# AGENDA TULSA METROPOLITAN AREA PLANNING COMMISSION Meeting No. 2719 April 6, 2016, 1:30 PM 175 East 2nd Street, 2nd Level, One Technology Center

## PRELIMINARY SUBDIVISION PLAT

### The Estates at the River II - (CD 8)

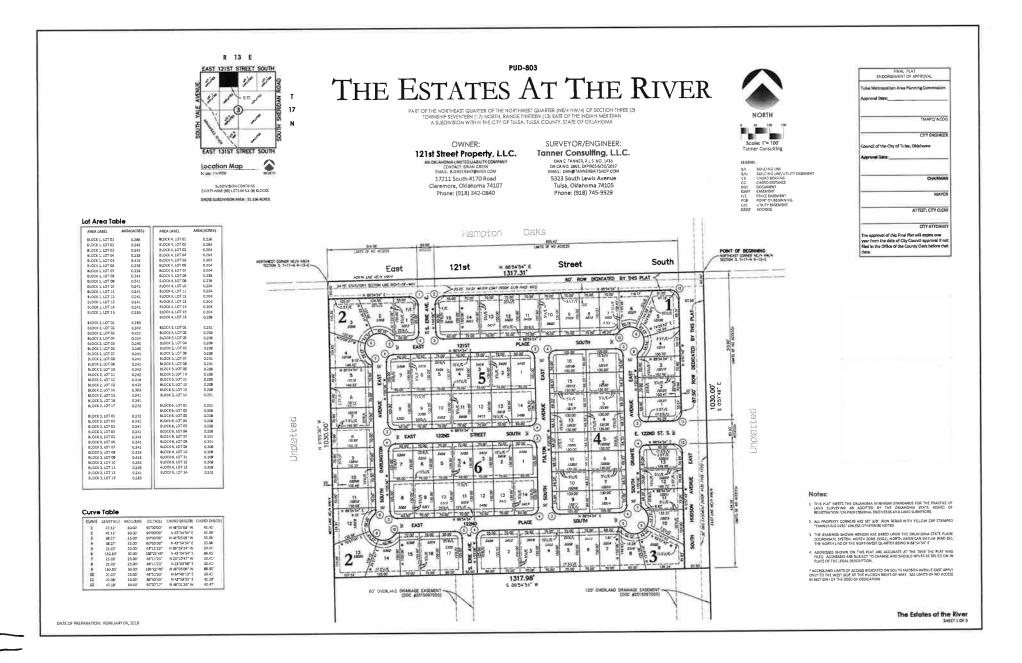
- **1. Zoning:** The property is zoned .Planned Unit Development 803.
- 2. Streets: Call out width of 123<sup>rd</sup> Street. Call out curve number on the face of the plat. Curve table has been provided without associated numbers shown on plan. There is a concern about where a proposed possible bridge alignment may be positioned near the development and how traffic coming across the bridge will travel near the development and how Yale Avenue would be utilized with a new traffic pattern..

- 6. Utilities: Telephone, Electric, Gas, Cable, Pipeline, Others: No comment.
- **7. Other: Fire:** An approved turnaround will be required if Hudson is more than 150 feet dead ended from the center of 123<sup>rd</sup> Street. Fire hydrant coverage will be required per IFC 2015 Section 5-7.5 this includes Hudson Avenue.

- 8. Other: GIS: Provide individual lot addresses for the plat. Submit subdivision data control sheet with final plat. Incorporate the point of commencement along with the bearing and distance into the legal description up to the point of beginning. Remove the parcel lines and lot labels in the location map. Show only the platted subdivisions and label all other land as unplatted. Graphically show all property pins found or set on the face of the plat. Addresses: South Hudson Avenue East should really be South Granite Place but it looks like The Estates at the River (which is just north of The

Estates at the River II) has the street name as South Hudson Avenue. If The Estates at the River can change the street name to south Granite Place, then The Estates at the River II should also change the name to South Granite Place.

1. The concerns of the Development Services and Engineering Services staffs must be taken care of to their satisfaction.

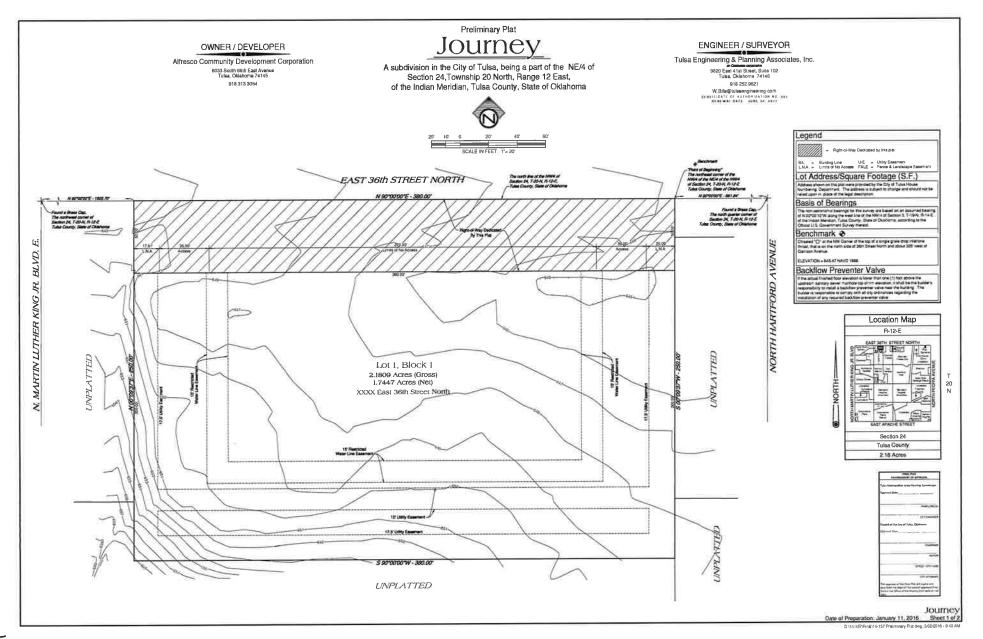
- **1. Zoning:** The property is zoned AG (agricultural), CS (commercial shopping) with MXI-U-55 zoning pending.
- 2. Streets: No comment.
- 3. Sewer: Explain gap between the off site 5 foot force main easement and the on site 17.5 foot utility easement. Provide and easement route to the off site sewer disposal system with widths; bearings and distances. In the covenant language include the sewer line easement language. Noc conceptual drawing was provided for the sewer disposal system for review. Meet conditions required on IDP 8165 sewer review. Access to an approved guaranteed method of sanitary sewer treatment is needed for approval. An off site septic system needs a permit from the Health Department for the septic system and the area must be inside an easement with the usage restrictions spelled out in the easement. The easement will be by separate instrument and must be filed before the IDP can be approved. Use language similar to the Privat Sanitary Sewerage sections in the TAM-BAO Buddist Temple Plat #4978.

- 4. Water: On the plat 20 feet of waterline easement is required instead of 15 feet, only when the proposed waterline easement is adjacent to another public utility easement can 15 feet be allowed. Add standard restrictive waterline easement language to the convenants. Add mainline gate valves; adjacent to the fire hydrants on the west/east segment of water main line.

- 5. Storm Drainage: The flood plain needs to be shown on the plat based on elevations and contained in an overland drainage easement. The conceptual utilities plan shows a building in the regulatory flood plain, accordingly any changes to the flood plain must comply with drainage criteria. It is anticipated that on site detention would be required whereas there is flooding directly downstream. Floodplain: the floodplain boundaries must be delineated on the plat as well as any necessary surface drainage easements or compensatory storage easements. Any proposed changed to the COT floodplain will require map revisions. All development shall be compliant with City of Tulsa Revised Ordinances Title 11-A.

- 6. Utilities: Telephone, Electric, Gas, Cable, Pipeline, Others: No comment.
- 7. Other: Fire: Aerial access will be required if building is over 30 feet high

Other: GIS: Not all subdivisions are identified correctly in the location 8. map. Some subdivisions are misspelled and some are missing. Submit subdivision data control sheet. Remove contours on the final plat submittal. Add City of Tulsa to plat sub title. Provide individual lot addresses. Graphically label the point of commencement. Graphically show all the lot pins found or set for plat. Define the basis of bearing. State the size of the project. Legal description needs to match plat. Make sure bearing angles are correct. POC bearing should be corrected. ADDRESSING: City of Tulsa Ordinance 22460 states the street name was changed from North Cincinnati Avenue to Martin Luther King Jr. Boulevard. The citys permitting system requires pre and post directional elements and therefore recognizes the street name as N Martin Luther King Jr BLVD East. An Infrastructure Development Process (IDP) permit is required for this project. The IDP permit must be officially signed and approved with an accompanying release letter before Final approval of the plat (contact Julie Miller). Sidewalks shall be constructed along East 36th Street North within a dedicated easement or within the right of way, with a minimum of five feet in width, and constructed in accordance with the specifications and standards of the City of Tulsa standards. Combine two separate easements to create a 32.5 foot easement to avoid gap between easements within the south portion of the plat. An overland drainage easement is required for the City of Tulsa Regulatory Floodplain boundaries. Use City of Tulsa plat covenant language. A SWP3 will be required.

1. The concerns of the Development Services and Engineering Services staffs must be taken care of to their satisfaction.

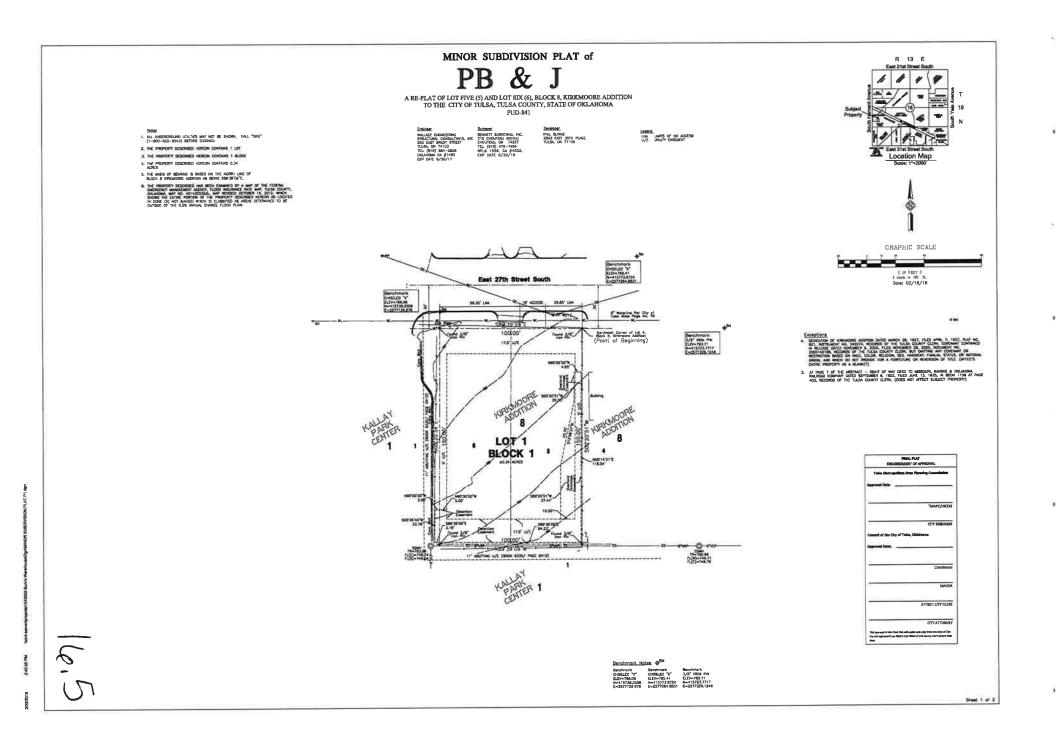
- 1. Zoning: The property is zoned PUD 841.
- 2. Streets: No comment.
- **3. Sewer:** On the conceptual plan, an 8 inch sanitary sewer main line exists along the back lot lines available for service connections.

- Water: There are no comments on the plat or covenants. On the conceptual plan a 6 inch waterline along East 27<sup>th</sup> Street South exists for water service connections. Provide stabilization over it during construction.

- 6. Utilities: Telephone, Electric, Gas, Cable, Pipeline, Others: No comment.
- 7. Other: Fire: Fire hydrant will be required within 400 feet of any nonsprinkled building and within 600 feet of sprinkled building as the hose lay...

- 8. Other: GIS: Identify all subdivisions on location map. Tie plat to section corner. Submit control data sheet. Add date of preparation. Provide addresses for plat and disclaimer. Provide legal, and email for engineer and surveyor, Remove the northing/easting coordinates associated with each benchmark location. Clarify owner information. Sidewalks need to be installed per City standards. Show existing right of way dedication. Use City standard covenant language. Legal: City Legal department changes per their approval is required.

1. The concerns of the Development Services and Engineering Services staffs must be taken care of to their satisfaction.

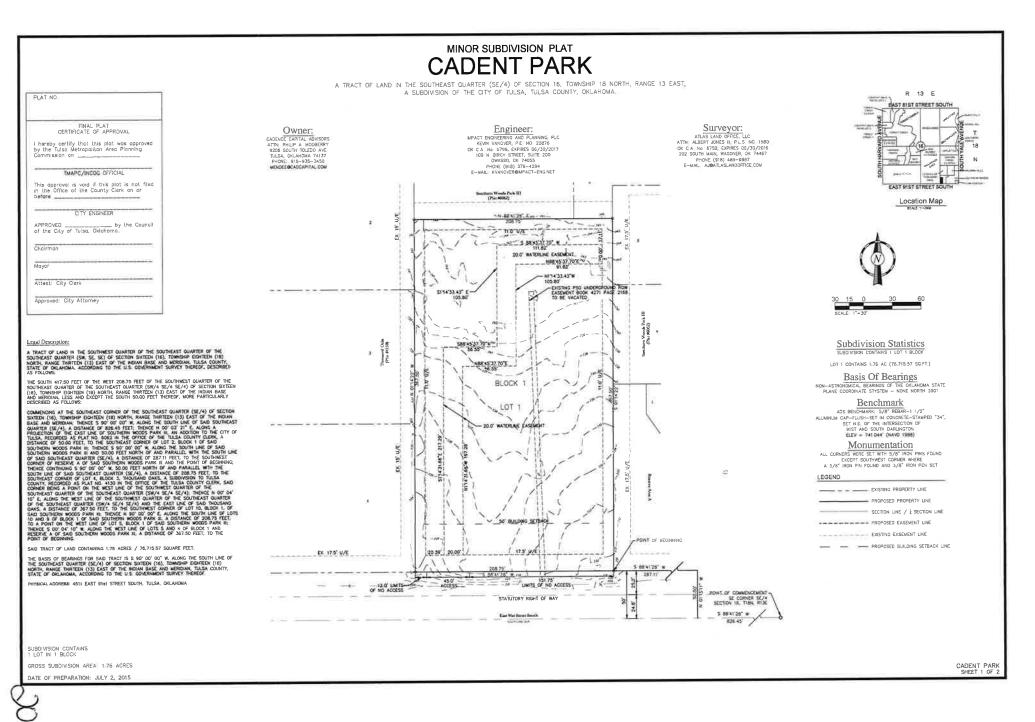
- 1. **Zoning:** The property is zoned OM/Planned Unit Development 831.
- 2. Streets: Call out right of way as "Dedicated by this Plat" or provide reference such as plat number or book/page number. Limit access to 36 feet. In covenants include section on Limits of Access. Delete section on mutual access easement as non is shown on the face of the plat. Reduce driveway width to 36 feet on the conceptual plan.

- **3. Sewer:** The conceptual plan shows buildings 2 and 3 using a common sewer service connection to the sanitary sewer main. This is not allowed. Each building will be required to have its own sanitary sewer tap for its sewer service line. The private sewer service line is not allowed to travel within the public utility easement in order to access the sewer main for service. It can cross the easement though.

- Other: GIS: Submit control data sheet. Provide individual lot address. 8. Define the basis of bearing between two known points. Take the paragraph on the left side and place under the Basis of Bearing heading on the right side. Add missing subdivisions in the location map. Correct existing subdivision boundaries inside township, range and section. Label project location in location map. Use a leader line. Correct legal description. Add PUD 831 to face of plat and within Deed of Dedication. Add the PUD restrictive covenants within the Deed of Dedication. The proposed dumpster enclosure on the east side needs to be pushed out by at least two feet so as not to encroach on the 11 foot utility easement. Sidewalks shall be constructed along East 91<sup>st</sup> Street South within a dedicated easement or within the right of way with a minimum of five feet in width, and constructed in accordance with the specifications and standards of the City of Tulsa. Public Works and Development Departments. Submit an IDP (infrastructure development plan) permit. Infrastructure plans need to be submitted before a

continued review of the plat can be conducted to determine the appropriateness and adequacy of the intended infrastructure. IDP plans need to be approved before making any further reviews or recommendations on this plat.

1. The concerns of the Development Services and Engineering Services staffs must be taken care of to their satisfaction.
